ADDENDUM #3

**CITY OF EAST PROVIDENCE
DEPARTMENT OF PUBLIC WORKS - ENGINEERING DIVISION
REQUEST FOR PROPOSALS
EP24/25-026
STORMWATER QUALITY IMPROVEMENT RETROFITS**

Addendum No. 3 forms a part of the Contract Documents and modifies the original Bidding Documents dated September 22, 2025 as noted below.

Addendum #3 - Questions and Responses

SOIL EROSION & SEDIMENT CONTROL PLAN - 1

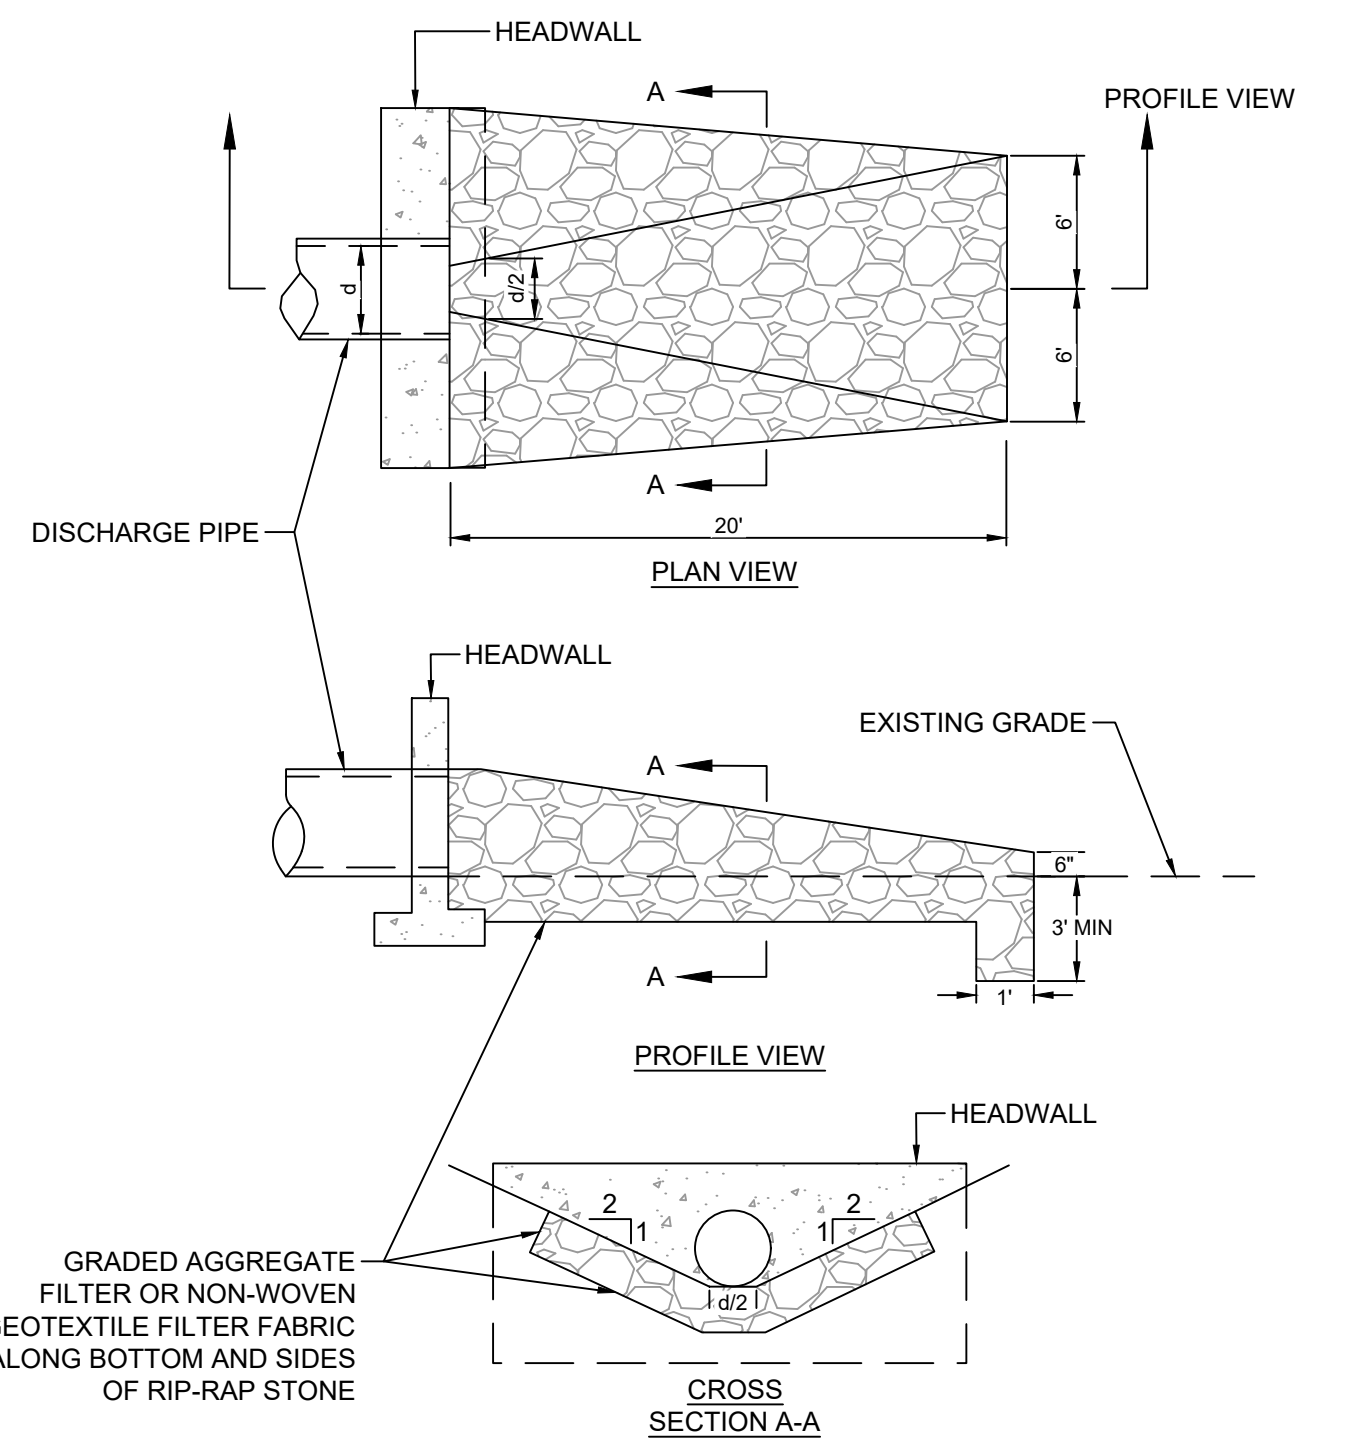
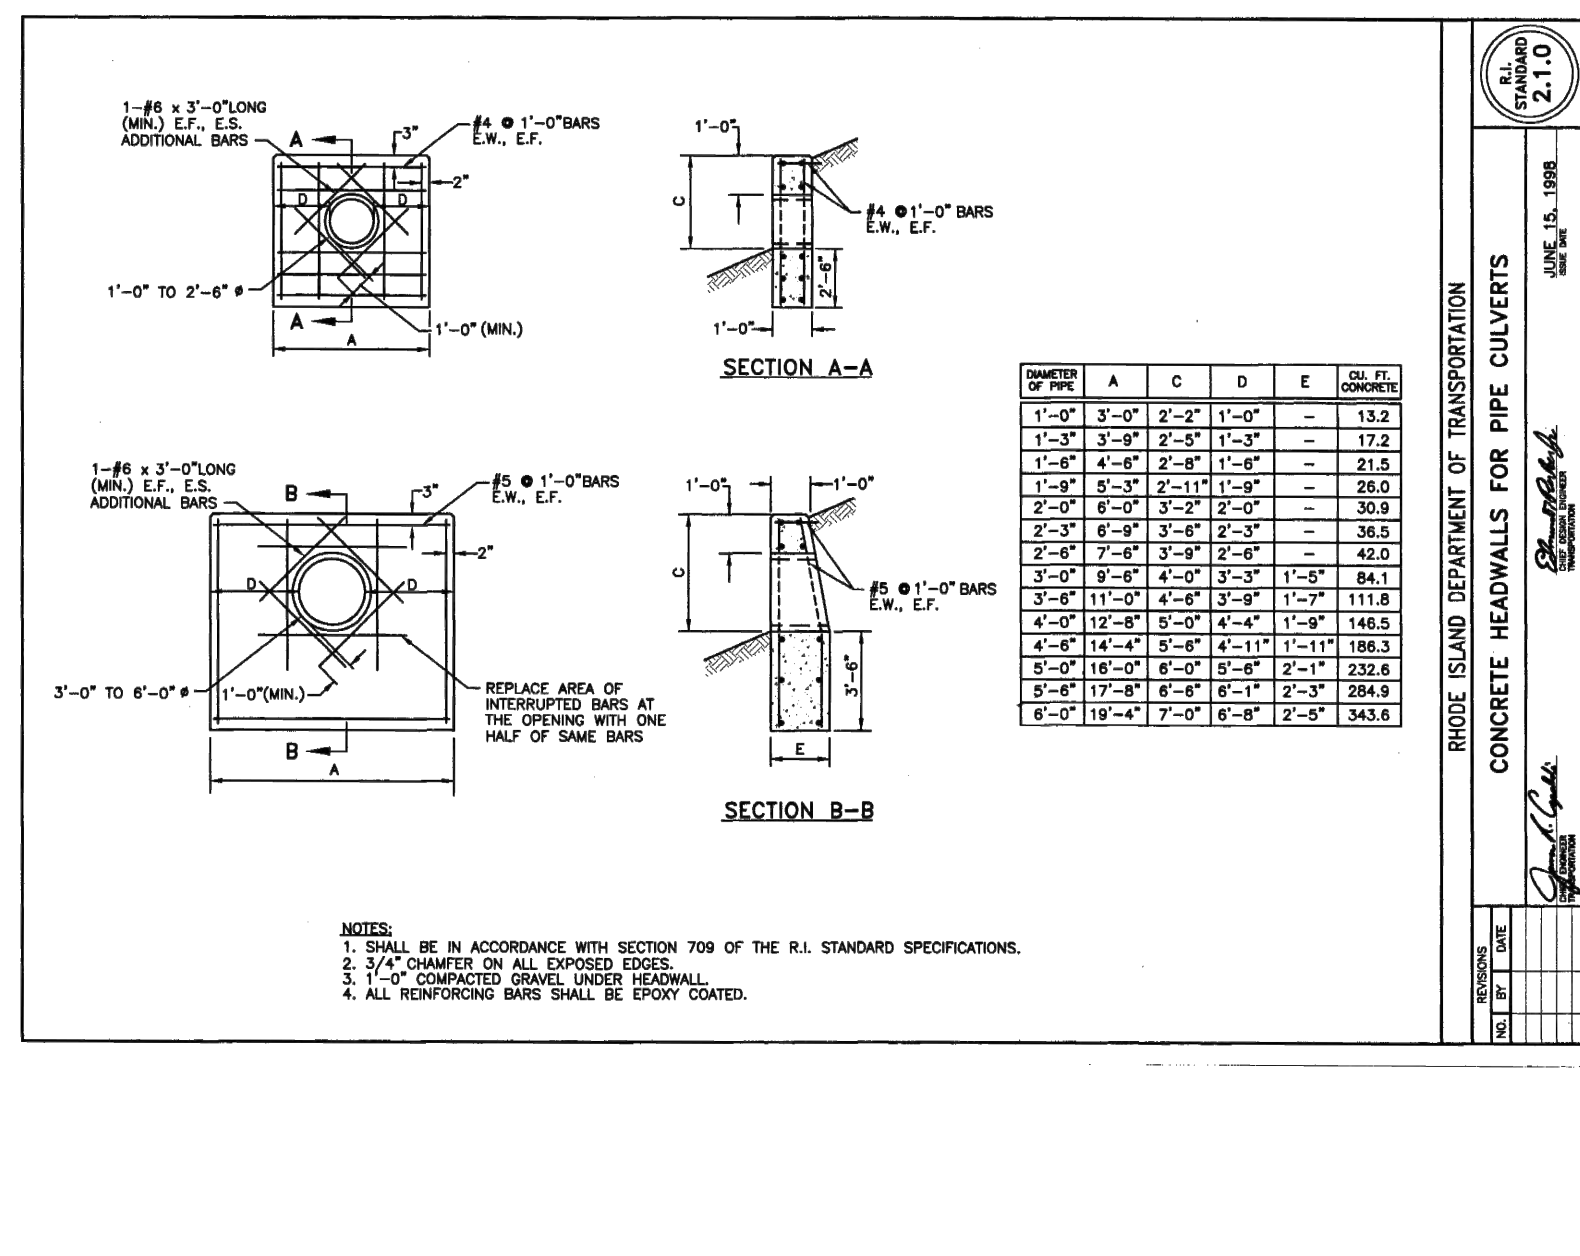
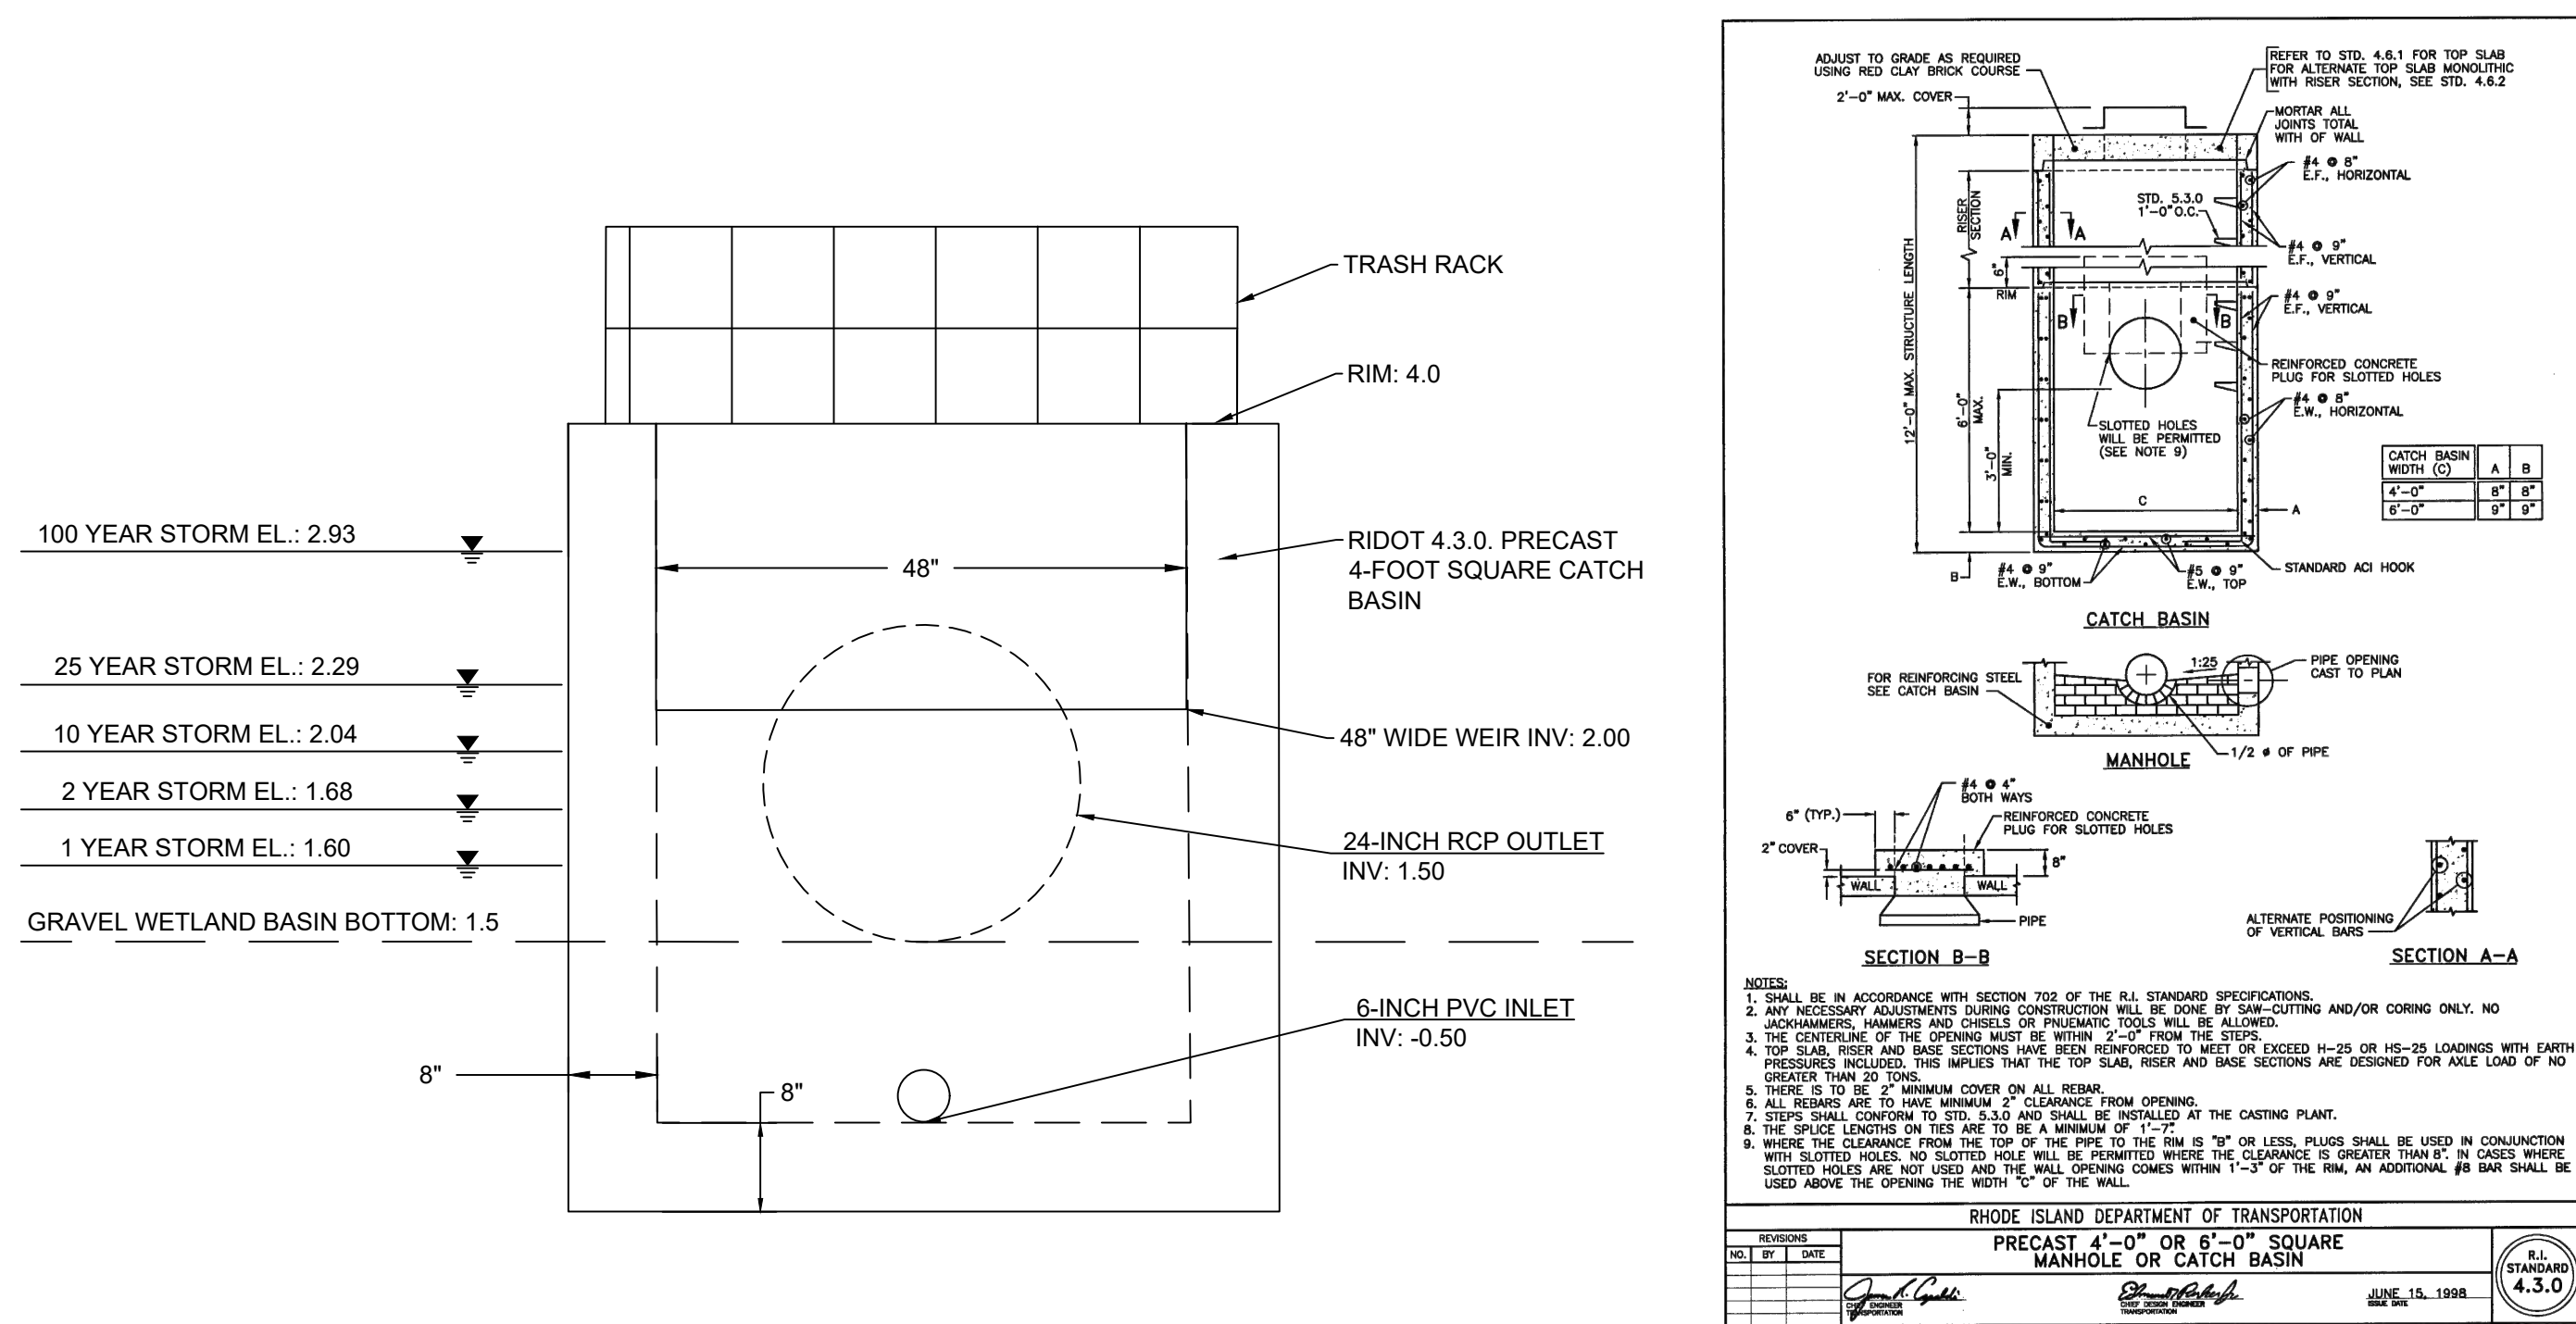
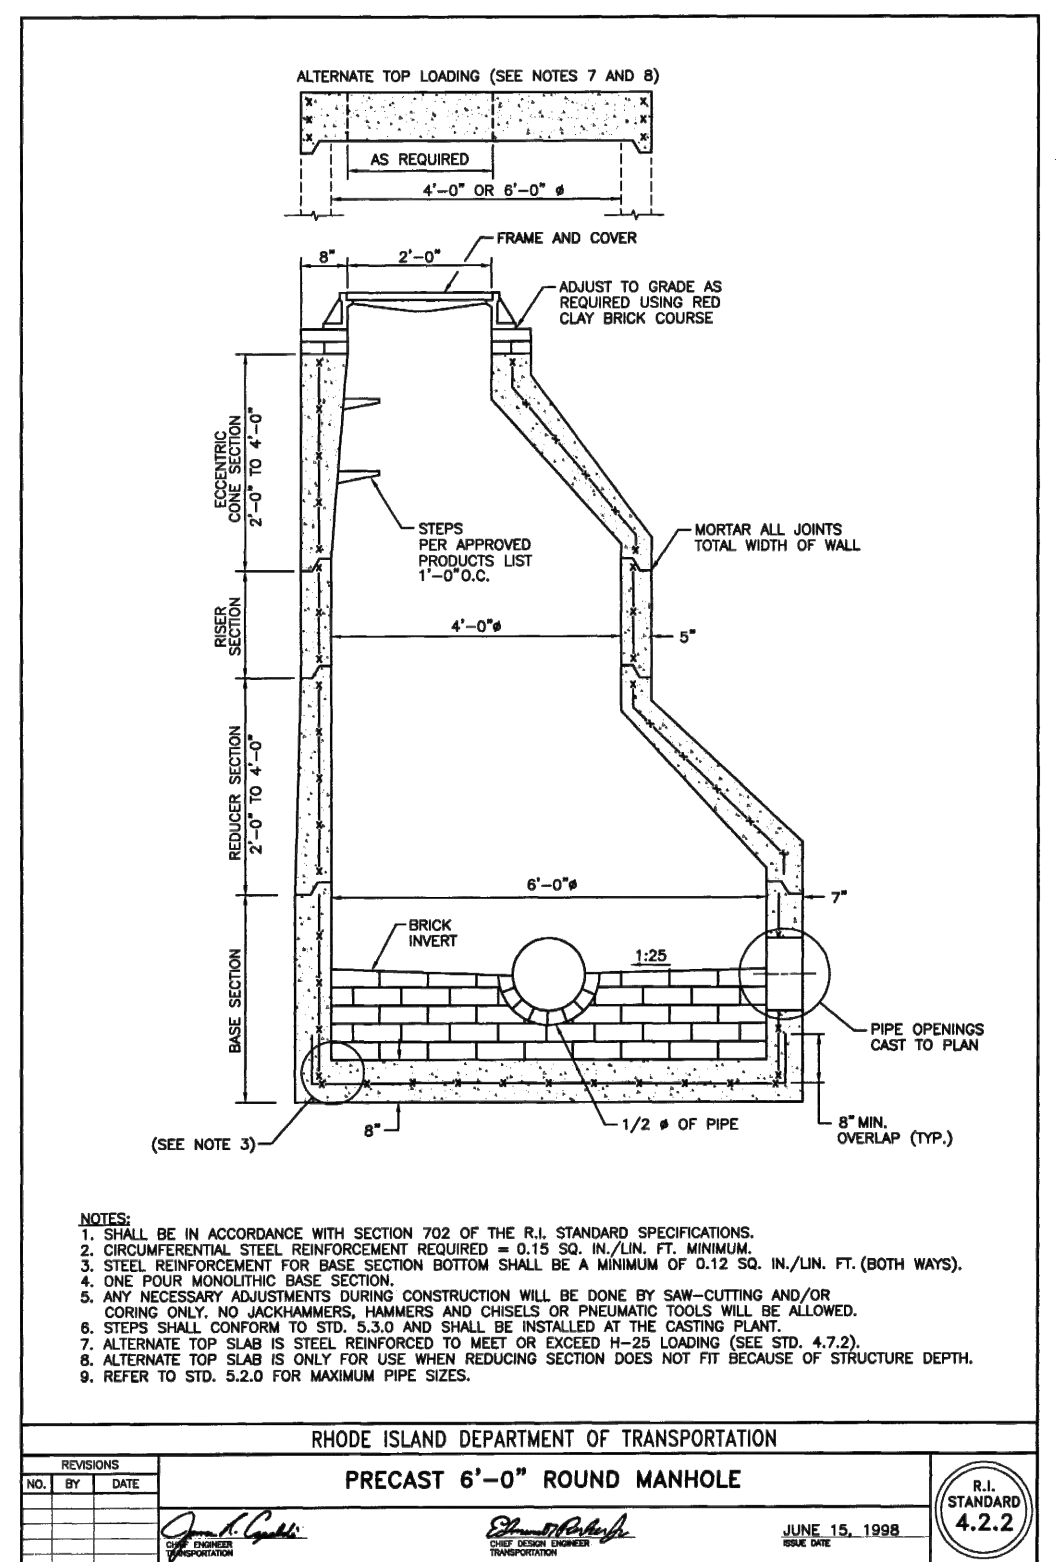
2. What pay item is "REMOVE AND REPLACE TIMBER GUARDRAIL" covered under referenced on drawing EC-1 also is there a detail for this?

5. Can you please confirm the match lines are in the correct locations for C-1/C-2 and EC-1 and EC-2?

The removal of the timber guardrail is covered under Item No. 2. It will not be replaced. The installation of new guardrails for both the sand filter (at the end of Locust Street) and the gravel wetland (at the end of Middle Street) is included under Item Nos. 4 and 6, respectively. Rhode Island Standard Detail No. 34.2.0 "Steel Beam Guardrail TL-3" is included on Drawing No. D-4. The guardrail should be installed in accordance with Section 901 of the Rhode Island Standard Specifications.

The match lines on Drawing Nos. C-1/C-2 and Drawing Nos. EC-1/EC-2 have been adjusted to the correct locations.
